**SUBDIVISION &
PLANNED UNIT DEVELOPMENT
STAFF REPORT**

Date: November 3, 2022

<u>DEVELOPMENT NAME</u>	Addison Woods Subdivision, Resubdivision of Lot 1 and Common Area
<u>SUBDIVISION NAME</u>	Addison Woods Subdivision, Resubdivision of Lot 1 and Common Area
<u>LOCATION</u>	6501 Addison Woods Drive (private street) (North side of Girby Road, 160'± East of Hillcrest Road).
<u>CITY COUNCIL DISTRICT</u>	District 6
<u>AREA OF PROPERTY</u>	2 Lots / 12.0± Acres
<u>CONTEMPLATED USE</u>	Subdivision approval to create one (1) legal lot of record from one (1) existing legal lot of record and a portion of an existing Common Area, and Planned Unit Development approval to amend a previously approved Planned Unit Development to allow reduced building setbacks and increased site coverage in a private street residential subdivision.
<u>TIME SCHEDULE FOR DEVELOPMENT</u>	Upon approval.
<u>ENGINEERING COMMENTS</u>

SITE PLAN

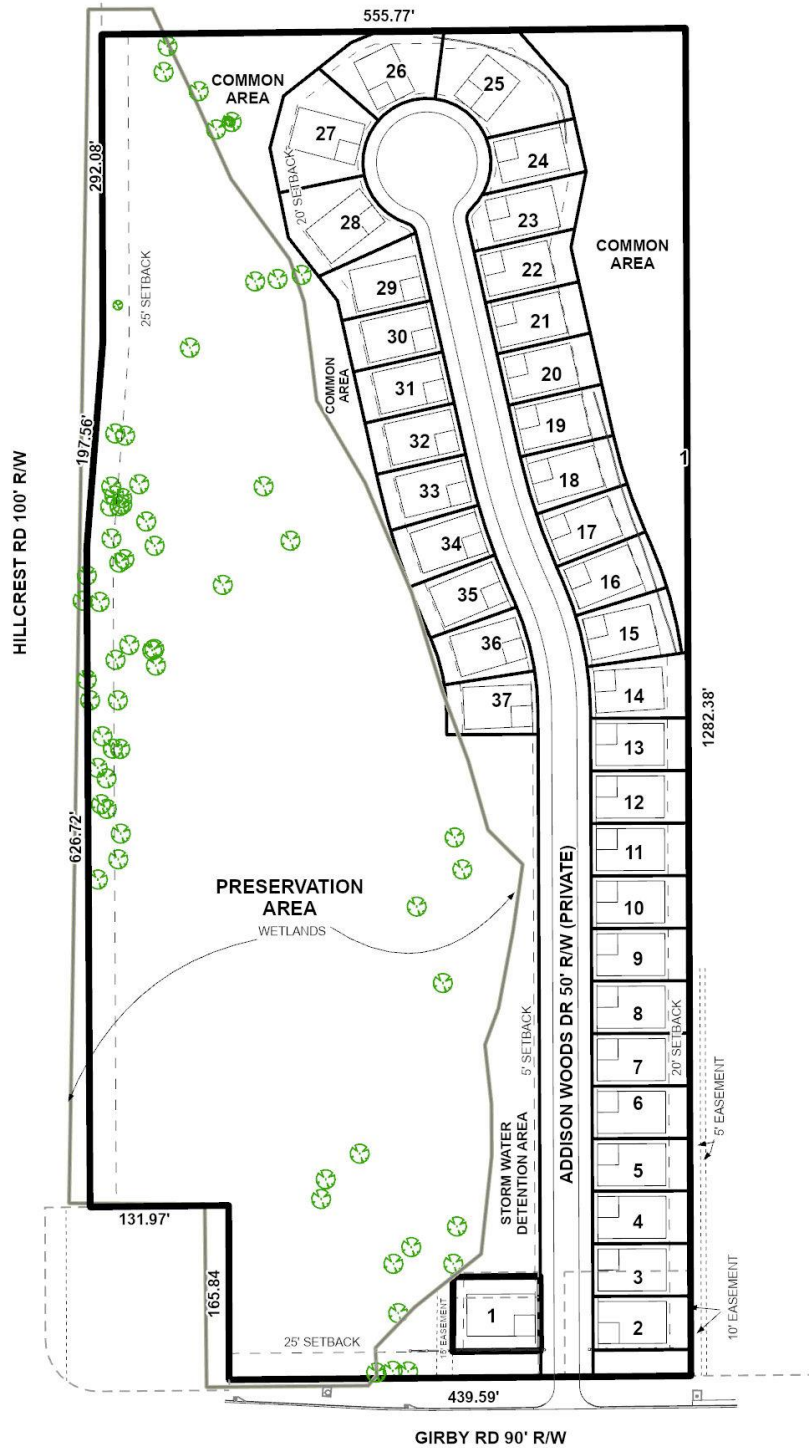
The increased site coverage allowance for Lot 1 is proposed to remain at 55 – 60% as per the previous PUD approval. The lot size label for Lot 1 in both square feet and acres should be retained on the site plan. However, the size of Lot 1 should be revised on the Lot Area table to reflect its size after its expansion as 5,912 square feet and 0.14 acres, to agree with the lot size label.

- 1) retention of the Minimum Building Setbacks (feet) table on the site plan;
- 2) revision of the setback table for Lots 29, 30, 31 and 34 as per the previous amended PUD;

- 3) retention of the lot size label in both square feet and acres for Lot 1, and revision of the Lot Area table to reflect the size of Lot 1 after its expansion as 5,912 square feet and 0.14 acres, to agree with the lot size label;
